**EPA Superfund  
Record of Decision:**

**Bruno Co-Op Association/  
Associated Properties  
Bruno, NE  
9/30/1998**

**RECORD OF DECISION**

**Bruno Cooperative Association/Associated Properties Site  
Bruno, Nebraska**

FIGURE 11

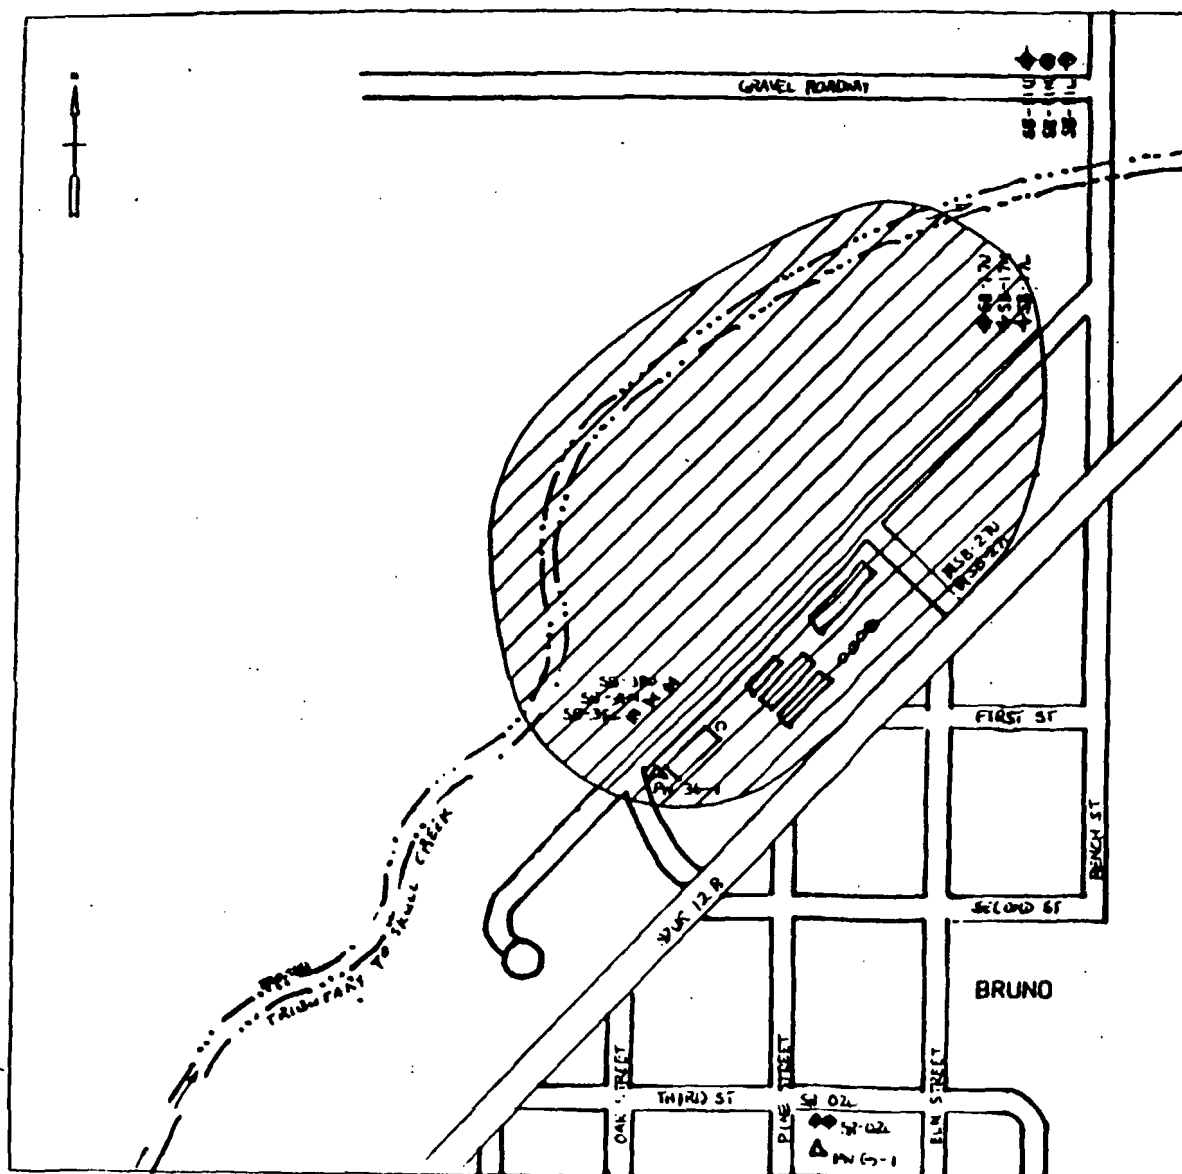
3) **Comment:** A commentor asked if the treatment system pumping would have any effect on neighboring wells by taking water from them or lowering the water table.

**Response:** The extraction system will be designed to cover the horizontal extent of the contaminated area as shown on Figure 11 in the ROD and should have little or no impact on any wells beyond the contaminated area. Wells inside the
